Access Compliance Report

Public Rights-of-Way

Intersection ID: 8879	Main Street: LAMBETH_DR	Cross Street: N_TRYON_ST	Location: NE
ADA ID: F9042ABF7A8B	Ramp Type: ParaDiag	Initial Pass/Fail: Fail	Overall Compliance: No
			Severity Score: 13.75

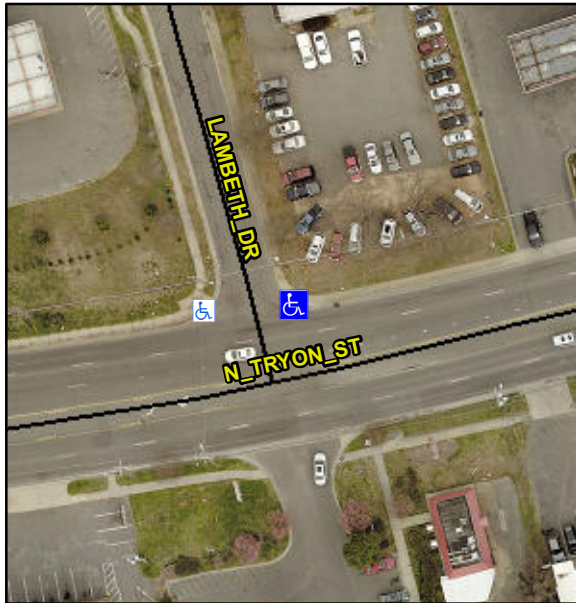
LT RP < 5%

R304.3.2, R304.5.3

Compliance	Description	Data	Compliance	Description	Data
N/A	Ramp Length LT (in)	54.5	N/A	Ramp Length RT (in)	49.0
Yes	Ramp Width LT (in)	54.0	Yes	Ramp Width RT (in)	59.0
Yes	Ramp Slope LT (%)	2.8	No	Ramp Slope RT (%)	10.1
Yes	Ramp XSlope LT (%)	1.9	No	Ramp XSlope RT (%)	2.1
N/A	Landing Length (in)	N/A	N/A	DWS Provided?	N/A
N/A	Landing Width (in)	N/A	N/A	DWS Contrast?	N/A
N/A	Landing Slope (%)	N/A	N/A	DWS Length (in)	N/A
N/A	Landing X Slope (%)	N/A	N/A	DWS Full Width?	N/A
N/A	Landing Curb? (Y/N)	N/A	N/A	DWS Offset (in)	N/A
N/A	Shared Landing?	N/A			
N/A	Gutter Ponding?	N/A	N/A	Gutter Slope (%)	N/A
N/A	Gutter Lip Ht (in)	N/A	N/A	Gutter X Slope (%)	N/A
N/A	Painted X Walk1?	No	N/A	Painted X Walk2?	No
	X Walk 1 Direction	To W		X Walk 2 Direction	To SE
N/A	X Walk 1 Width (in)	N/A	N/A	X Walk 2 Width (in)	N/A
	X Walk 1 Slope (%)	0.9		X Walk 2 Slope (%)	3.2
	X Walk 1 X Slope (%)	3.2		X Walk 2 X Slope (%)	1.0
N/A	Ramp inside XWalk1?	N/A	N/A	Ramp inside XWalk2?	N/A

Remove & Replace Curb Ramp With Two New Directional Ramps or Equivalent.
